CITY OF ALBUQUERQUE

RE: **Lot 9 Block 13 Unit 5 S.A.D. 227**
6519 Jade Dr. NW
Grading and Drainage Plan
Engineers Stamp Date 4/22/19 (E10D062)

DRAINAGE AND TRANSPORTATION INFORMATION SHEET (REV 6/2018)

ENGINEER'S SEAL 	Lot 9, Block 13 Volcano Cliffs Unit 5	DRAWN BY JDC
	GRADING AND DRAINAGE PLAN	DATE 04/20/2019
4/22/19	 Rio Grande Engineering 1606 CENTRAL AVENUE SE SUITE 201 ALBUQUERQUE, NM 87106 (505) 872-0999	SHEET # 1 OF 1
DAVID SOULE P.E. #14522		JOB #

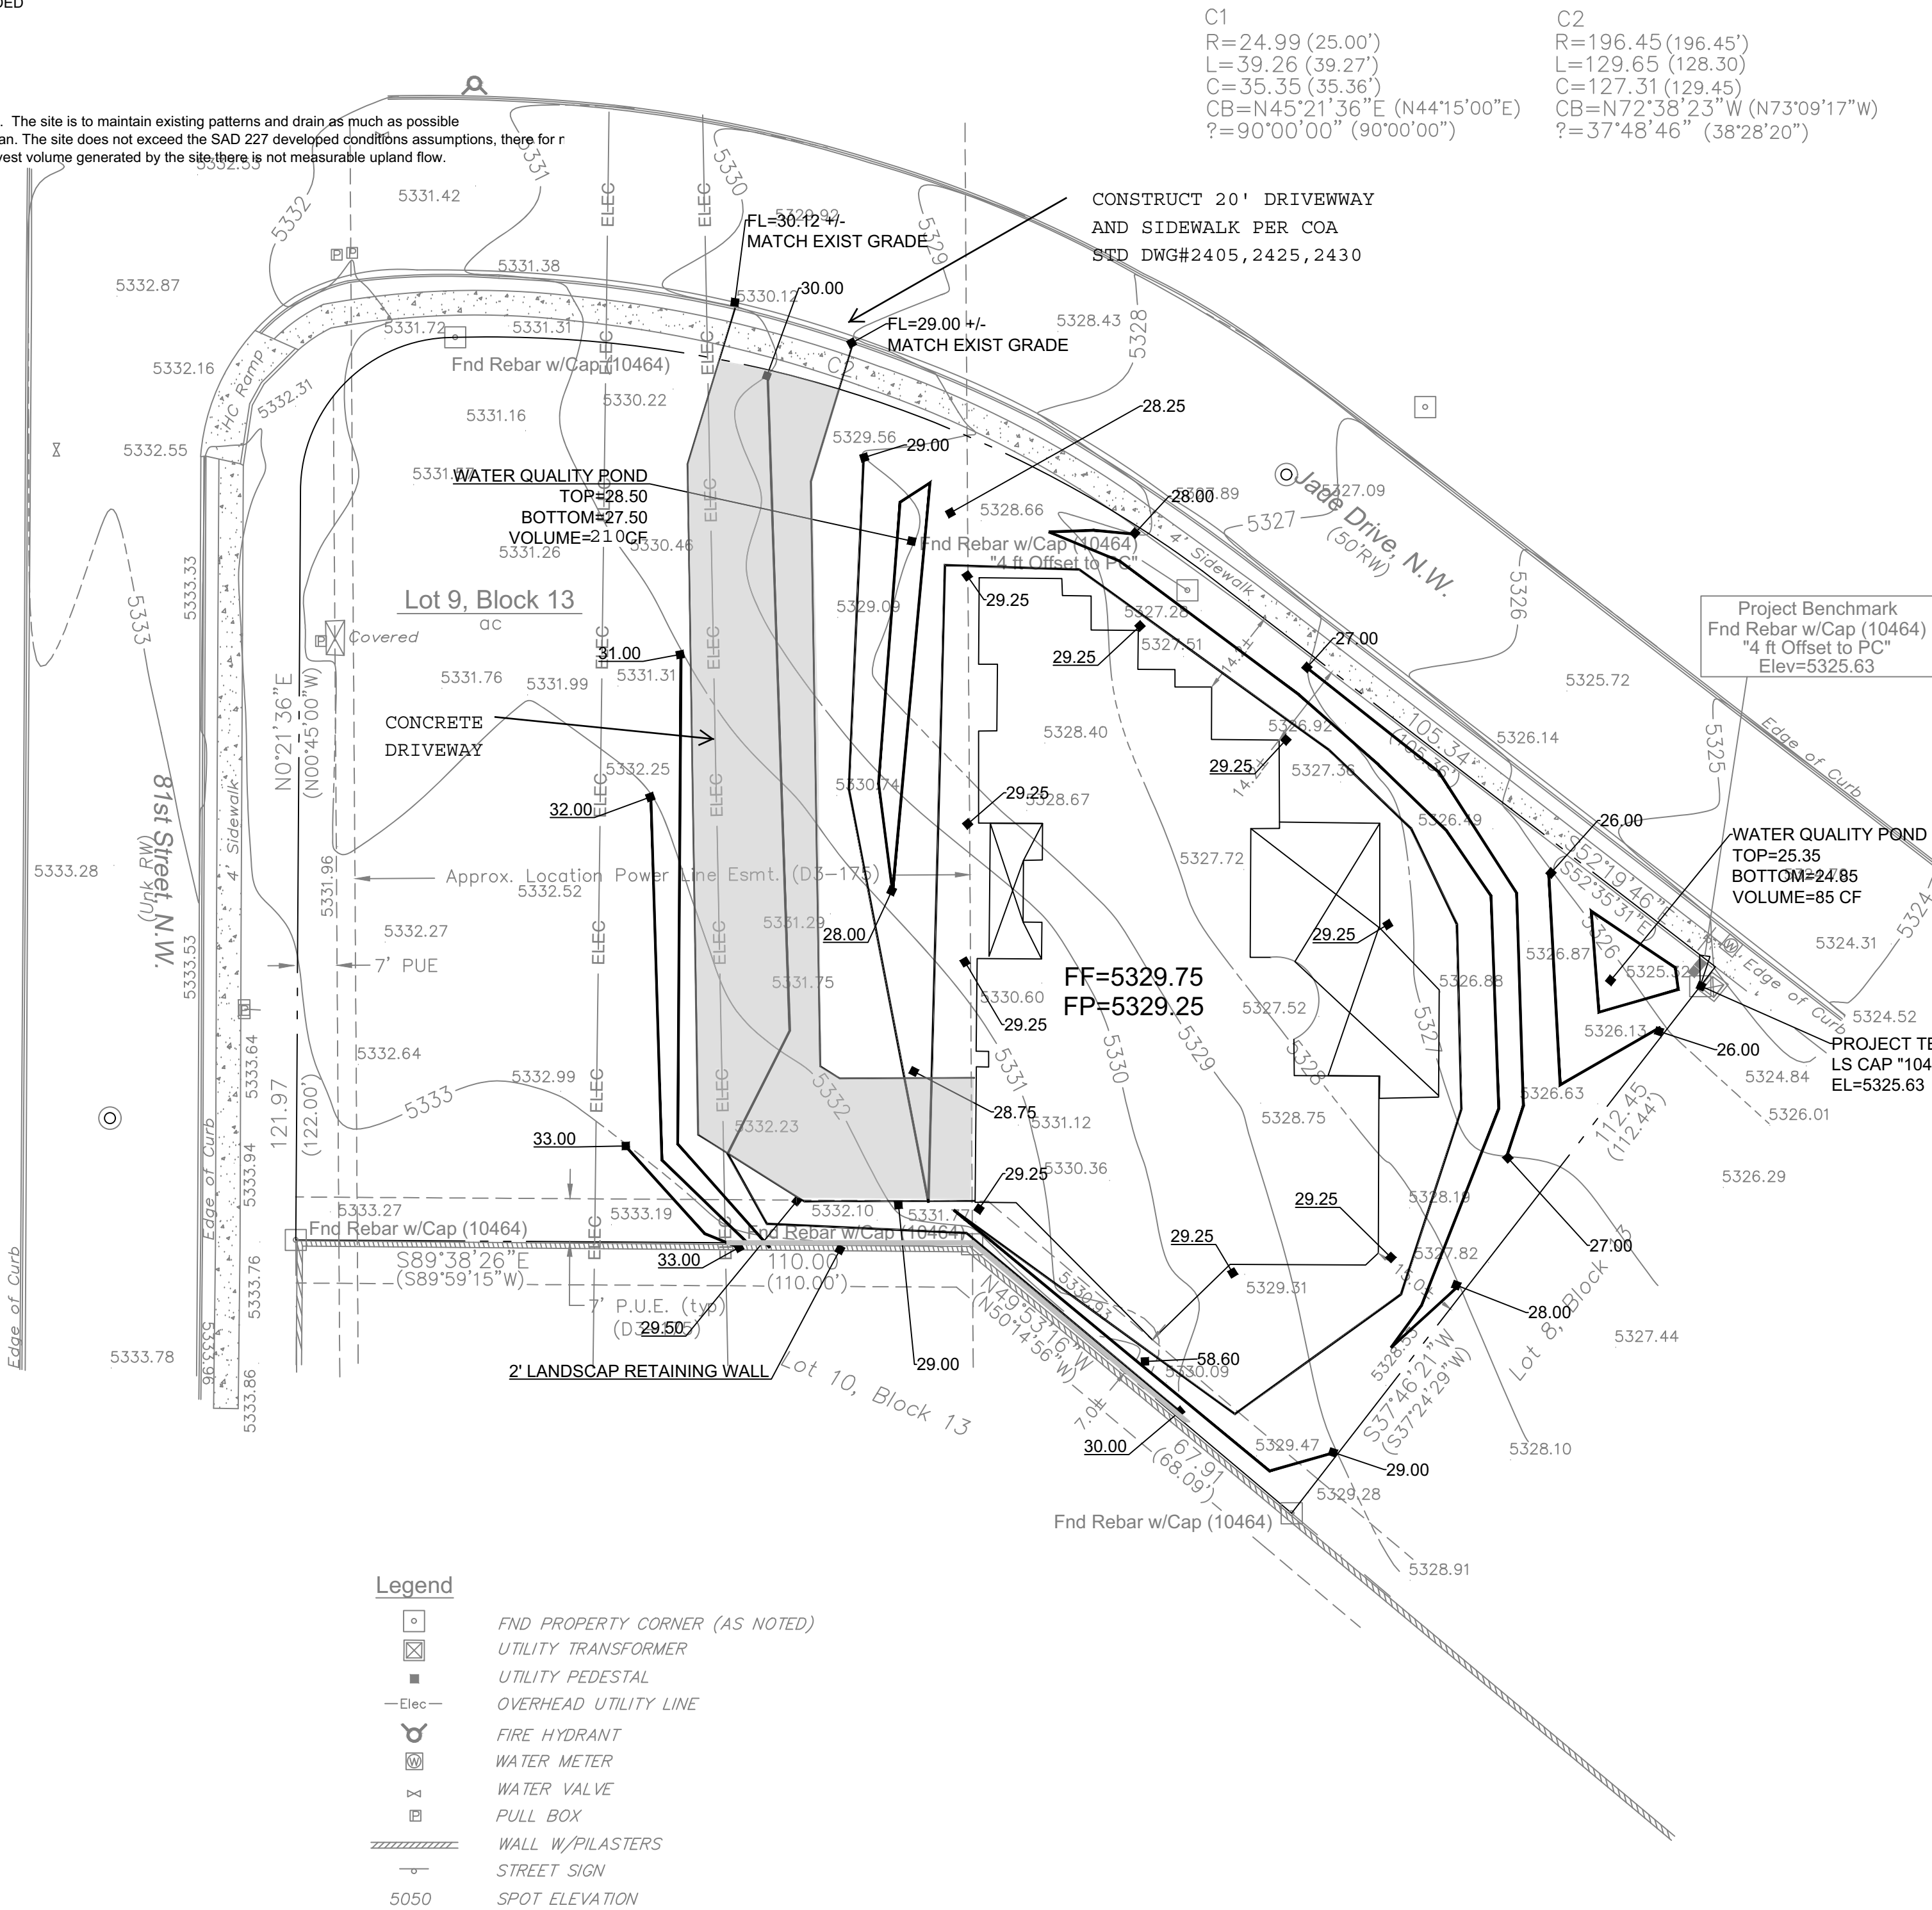
Reiterate to the Owner/Contractor that a separate permit for any garden/retaining wall must be obtained, with the approved G&D plan.

Prior to Building Permit approval, a **Pad Certification** will be required. Inform the contractor/owner not to pile dirt in the street as a ramp to climb the curb. If dirt is found in the street the pad cert. will be denied.

Prior to **Certificate of Occupancy release**, Engineer Certification per the DPM checklist of this plan will be required.
